TOYOTA Service Bulletin

Section :	Body Electrical
Ref. No. :	BE-0020
Date :	Jul., 2000
Page :	1 of 2

Model Name : LAND CRUISER

Subject : SUPPLEMENTAL FOR REPAIR MANUAL

I01673

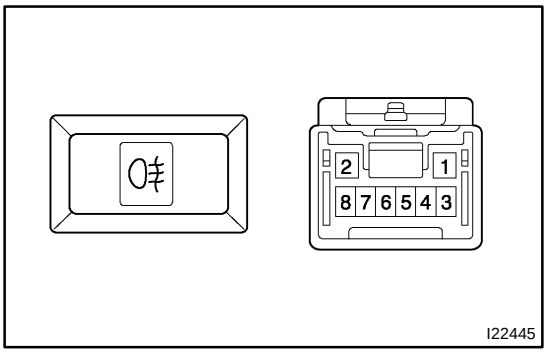
This Service Bulletin is to inform you of the inspection procedure for rear fog light system due to the change of the rear fog light switch from July, 2000.

1. INSPECT REAR FOG LIGHT SWITCH CONTINUITY

Switch position	Tester connection	Specified condition
OFF	-	No continuity
ON	2 - 5	Continuity
Illumination circuit	2 - 8	Continuity

If continuity is not as specified, replace the switch.
